**CONSTRUCTION BULLETIN
No. 1**

Institution: Calipatria State Prison - CAL

Reference: Project #18-045, Replace Roof, Phase 11, including

Description: This bulletin is to revise the roof slope to the existing ¼” per foot and to revise the parallel AHU’s crickets to 1 ½” per foot on the upper roof per RFI 003 response. Plans and Sections have been revised show the updated roof slope. Parapet,

HA4.1

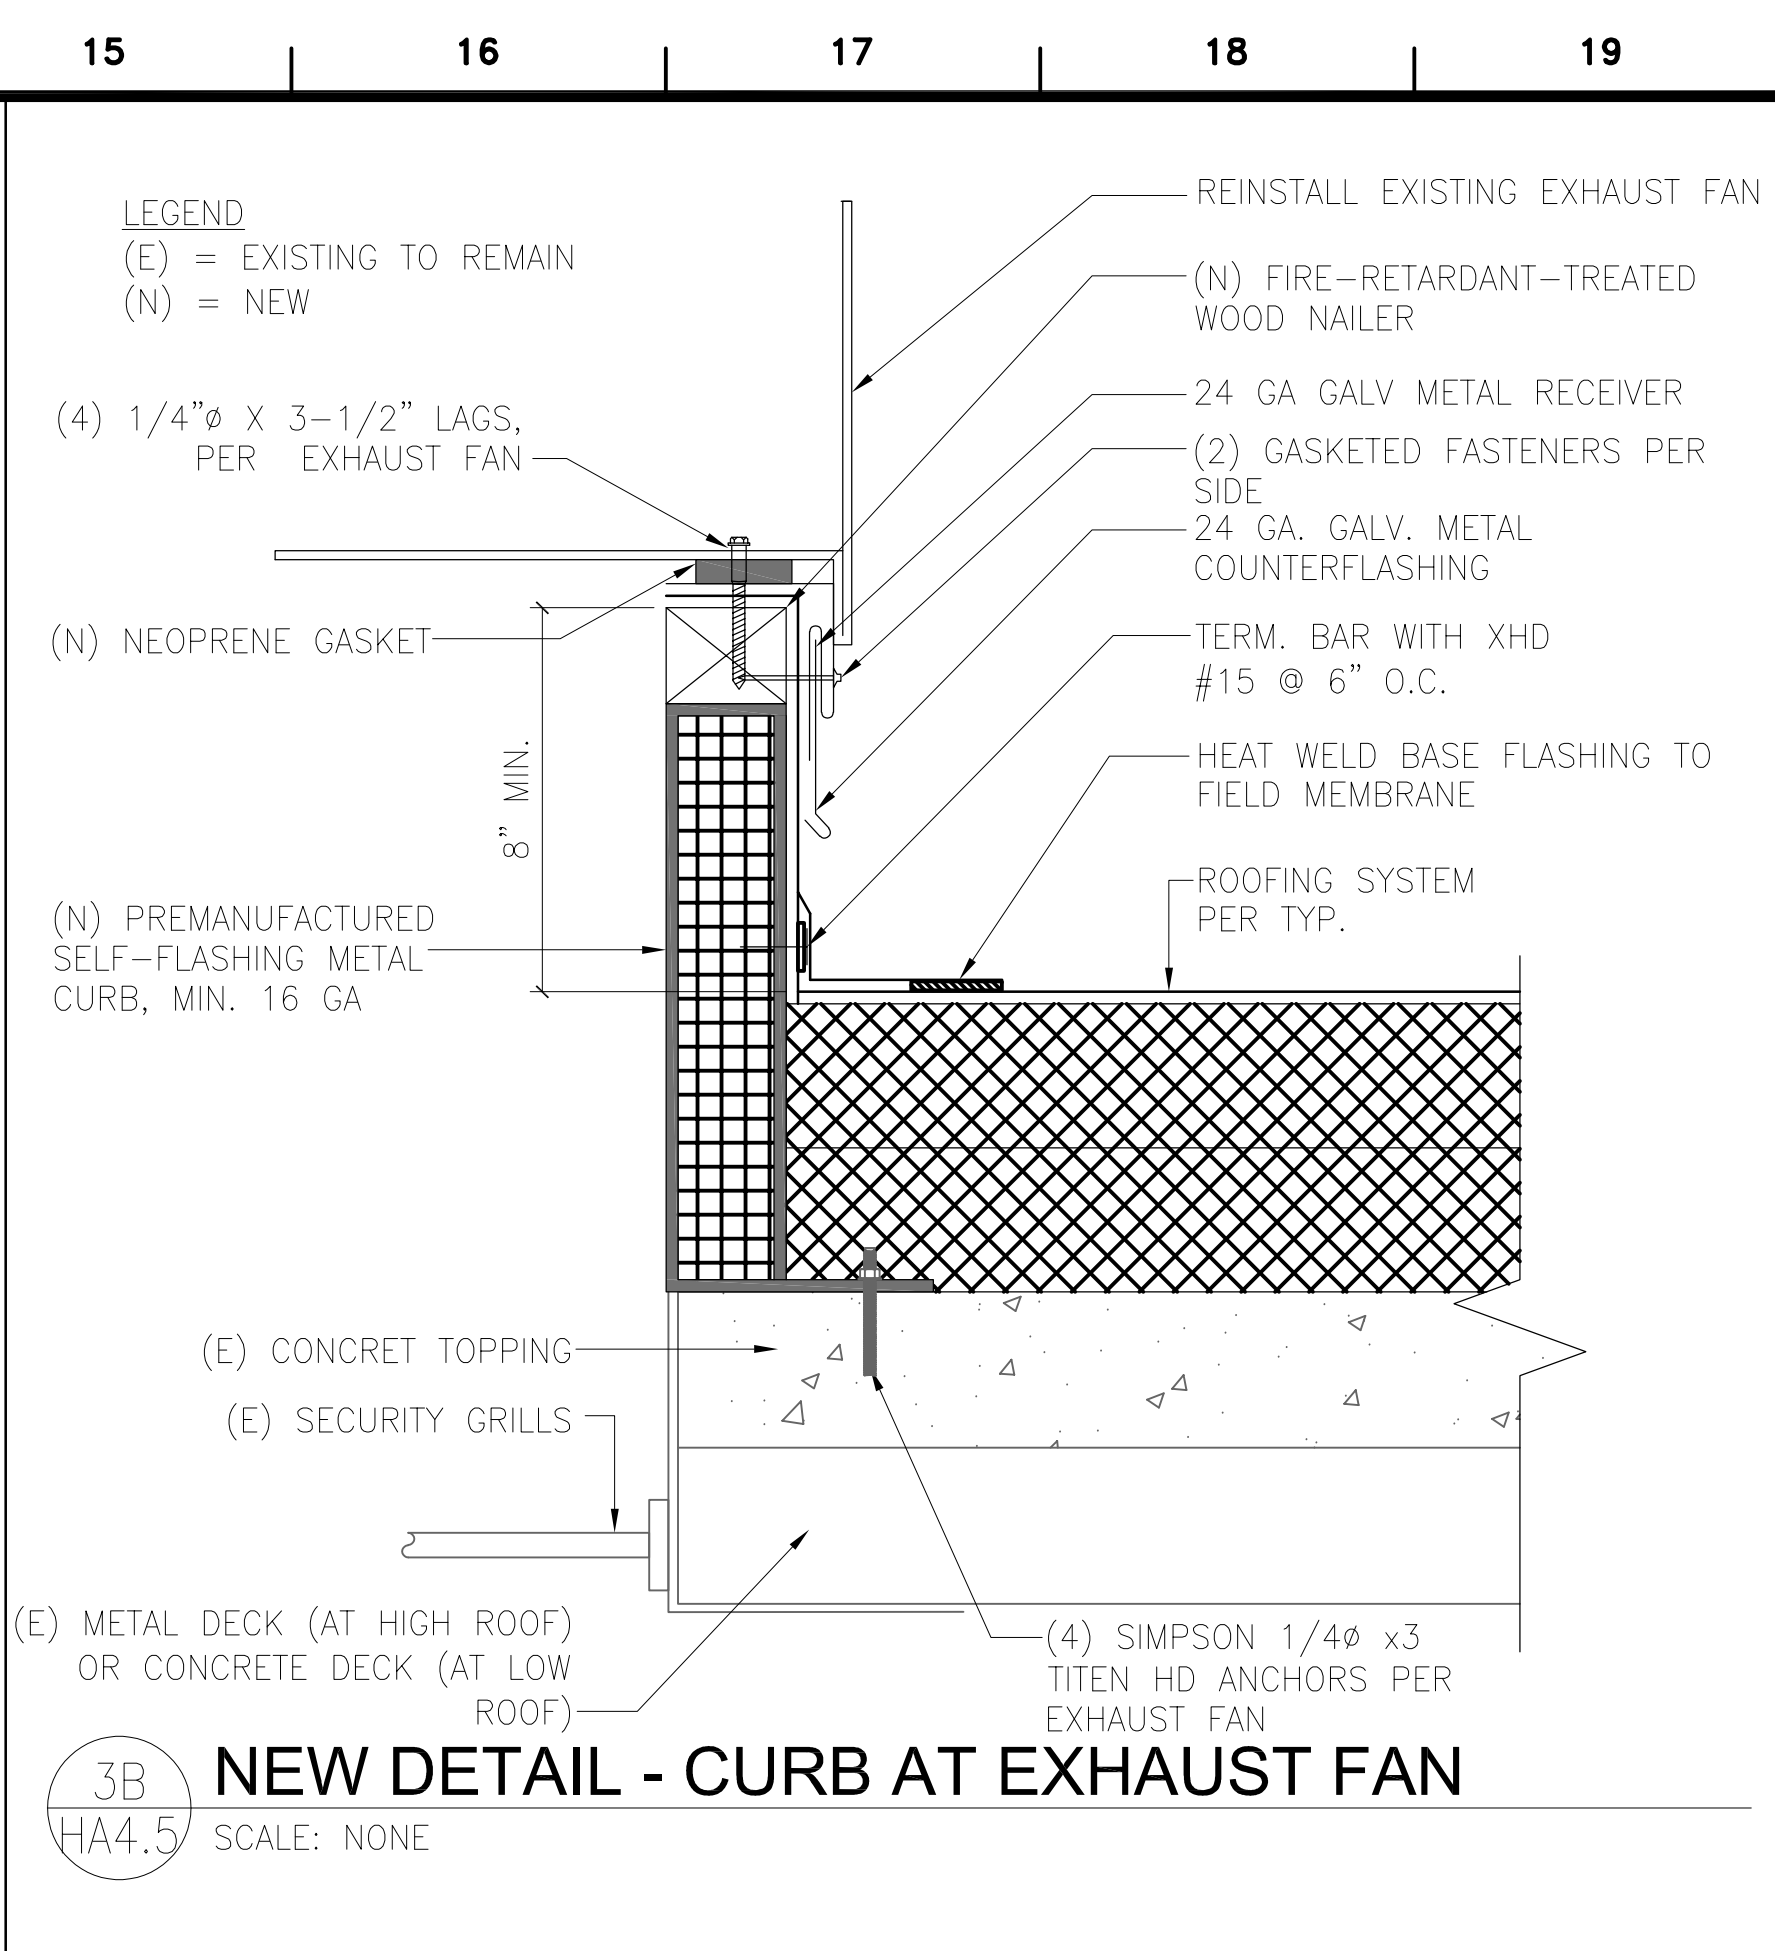
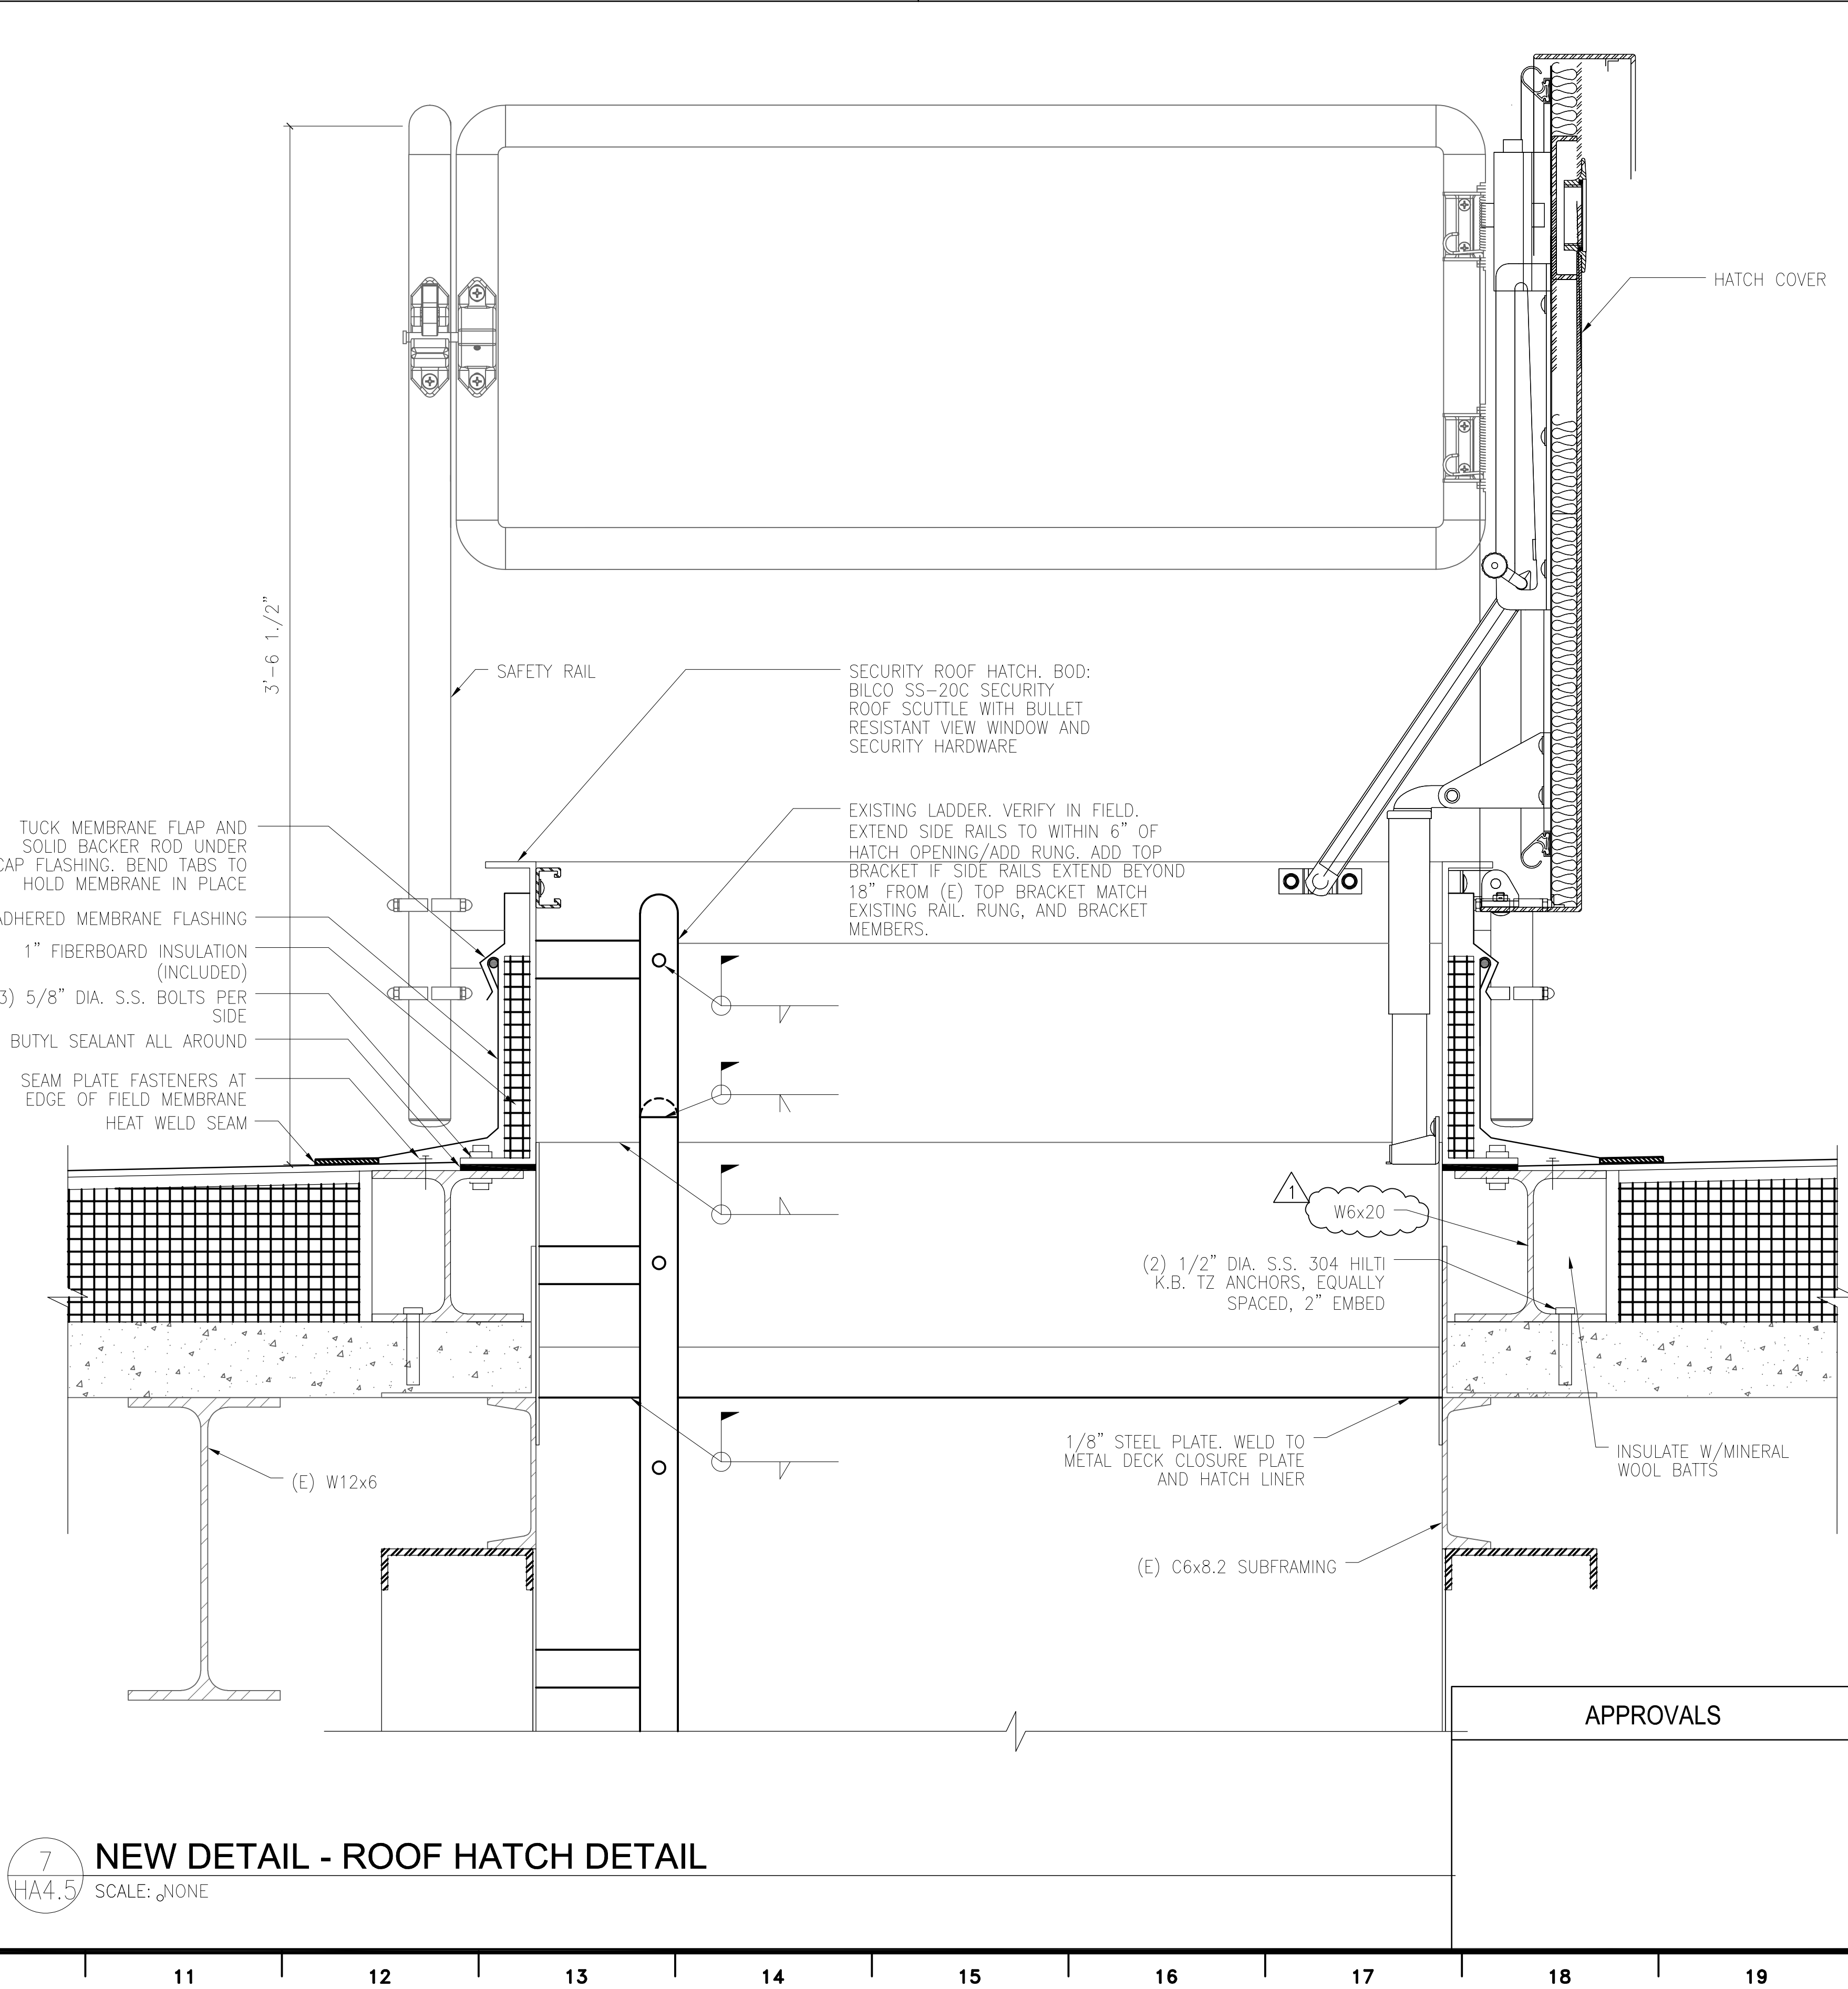
- c. Revised Guardrail slope and top of roof elevation per roof slope revision, see D/HA3.3
16. Sheet HA4.1:
 - a. Revised parapet detail to reduce parapet height per reduction of roof slope. See detail 1B/HA4.1.
